NRC'S HANDOUT

REQUEST FOR ADDITIONAL INFORMATION
TECHNICAL SPECIFICATION AMENDMENT
STEAM GENERATOR TUBE INSPECTIONS WITHIN TUBESHEET
TAC NO. MD0197
WOLF CREEK GENERATING STATION
DOCKET NO. 50-482

LICENSEE'S HANDOUT

Revision to TS 5.5.9, "Steam Generator (SG) Program"

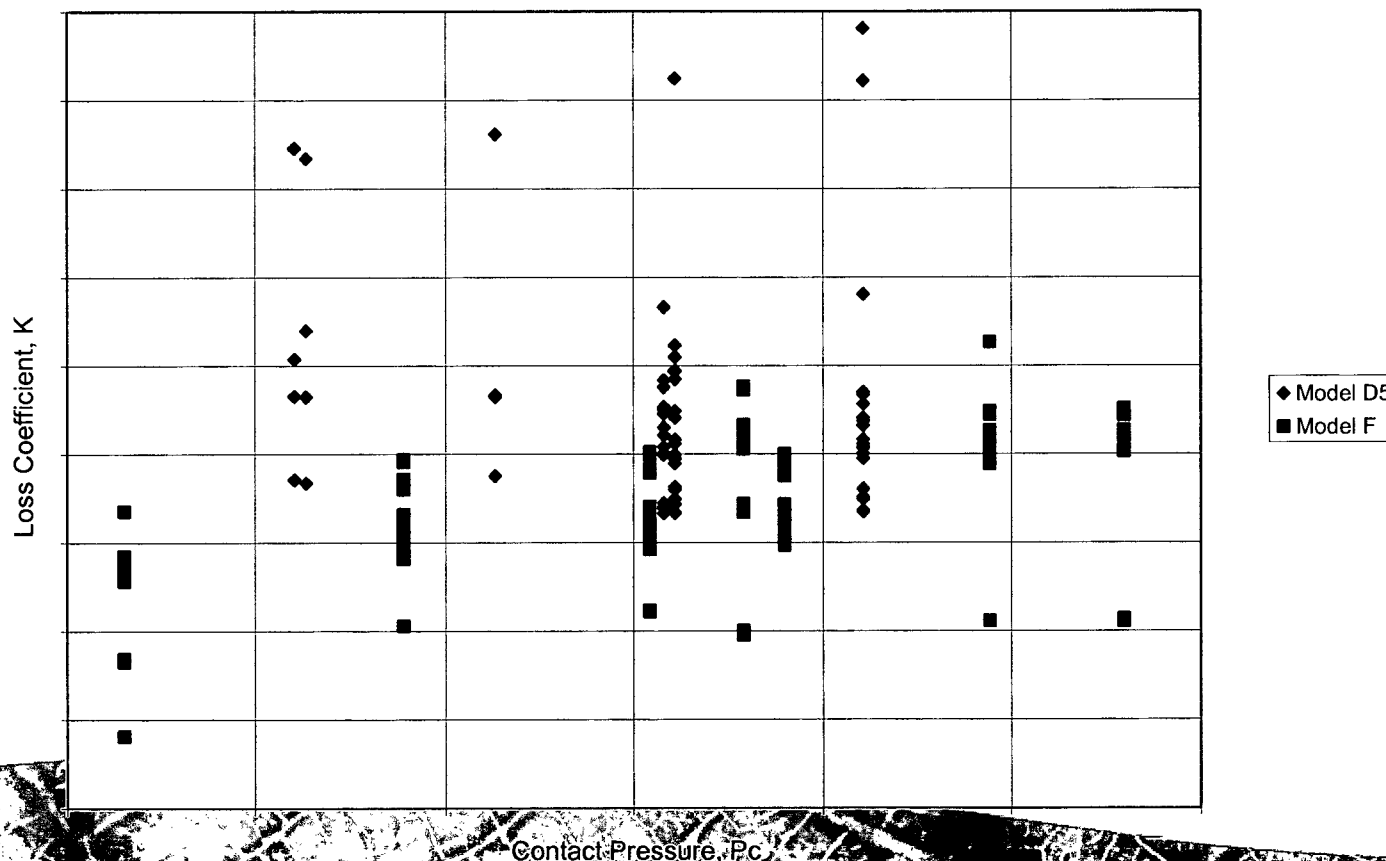
12. Figure 13 of Reference 2, Enclosure I contains additional loss coefficient data taken from the crevice pressure study in the white paper. Provide a figure showing all individual data points from which Figure 13 was developed. Describe the specific applied pressure differentials from the crevice pressure study used to calculate the contact pressure for each data point.

12. Figure 13 of Reference 2, Enclosure I contains additional loss coefficient data from previous leak test results not from the crevice pressure study in the white paper. Provide a figure showing all individual data points from which Figure 13 was developed. Describe the specific applied pressure differentials from the crevice pressure study used to calculate the contact pressure for each data point.

- The data supporting Figure 13 is provided below:

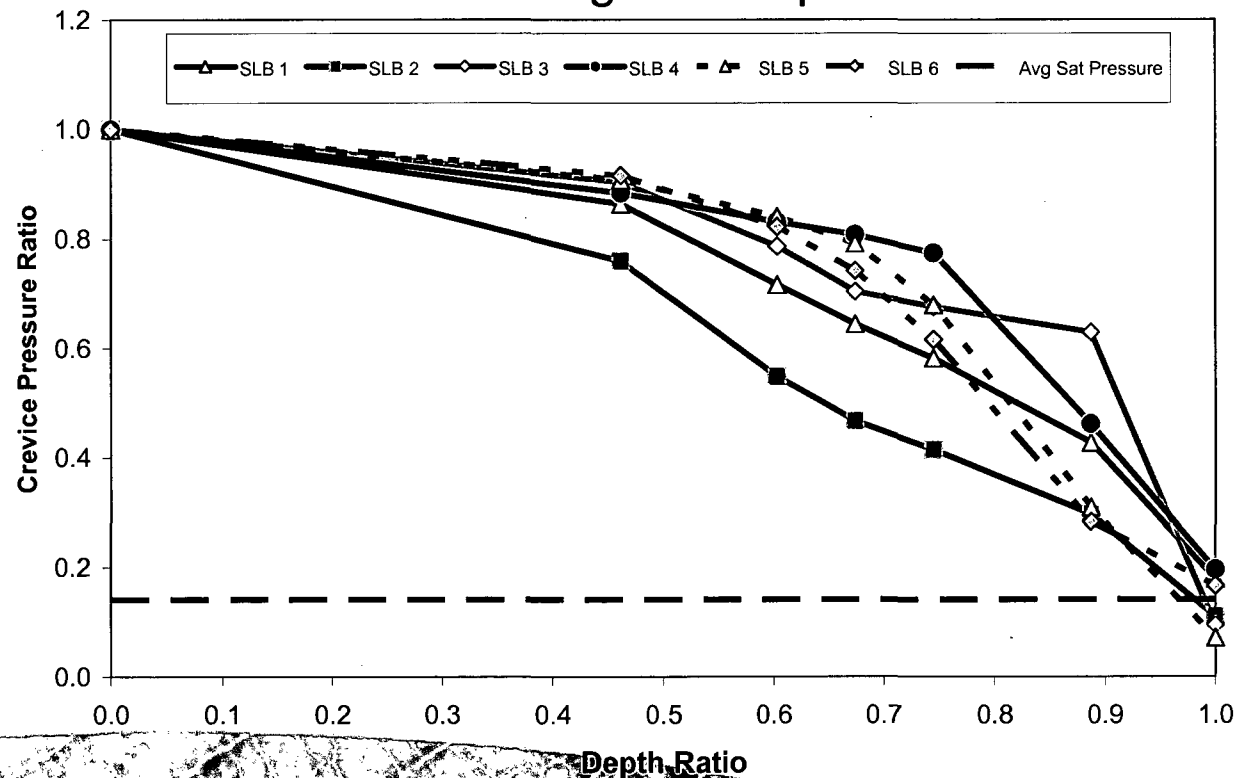
20. Reference 2, Enclosure 1, Attachment 1 - The pressure tap locations in Figure 2 are different from those shown in Figure 3. Discuss and explain this difference or provide corrected figures.

20. Reference 2, Enclosure 1, Attachment 1 - The pressure tap locations in Figure 2 are different from those shown in Figure 3. Discuss and explain this difference or provide corrected figures.

- The ordinate values, the horizontal axis, in Figure 2 of the White Paper are correct. The ordinate values used in the original Figure 3 were incorrect. The revised version of Figure 3 is provided below.

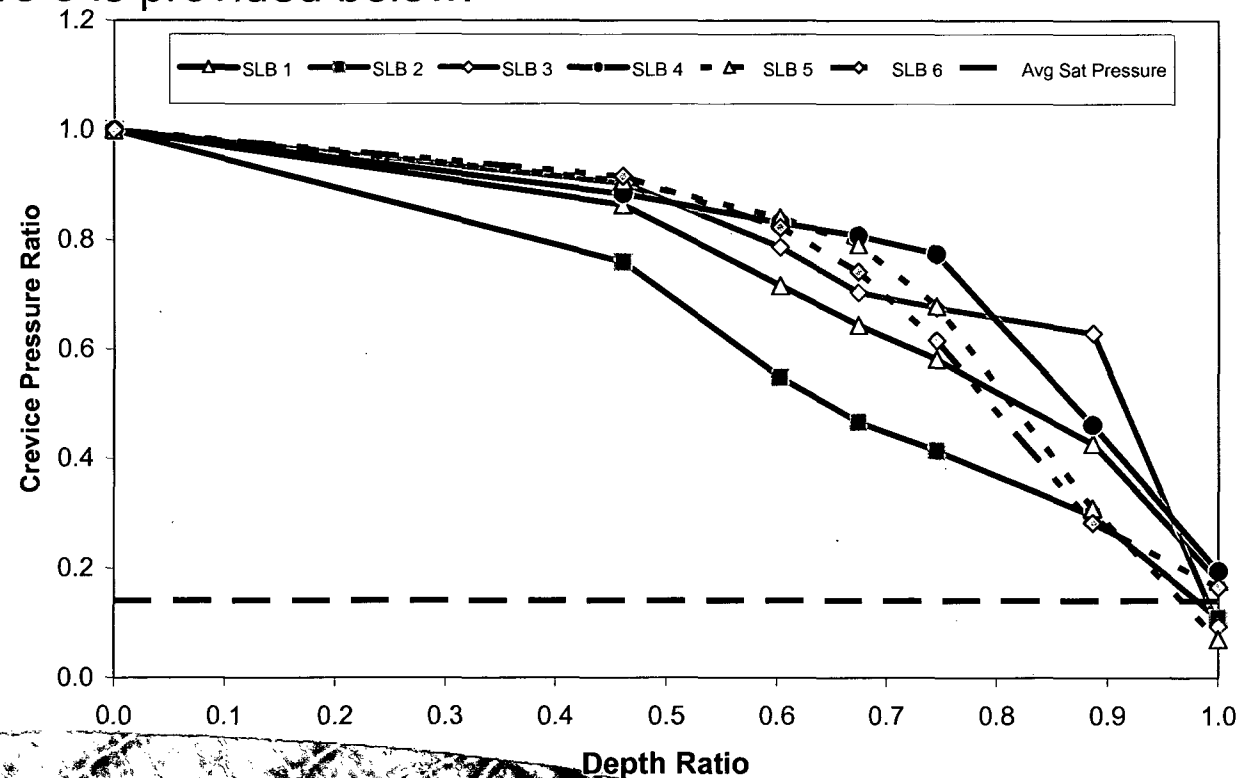
22. Reference 2, Enclosure 1, Attachment 1 - Figure 3 refers to tests labeled SLB 9 and SLB 10 which are not listed in Table 2. Discuss and explain this, or provide a revised Table 2 and Figure 3 showing all test results.

22. Reference 2, Enclosure 1, Attachment 1 - Figure 3 refers to tests labeled SLB 9 and SLB 10 which are not listed in Table 2. Discuss and explain this, or provide a revised Table 2 and Figure 3 showing all test results.

- The White Paper will be revised to correct any typos in the text or figures.
- The data in Table 2 is correct.
- A revised Figure 3 is provided below.
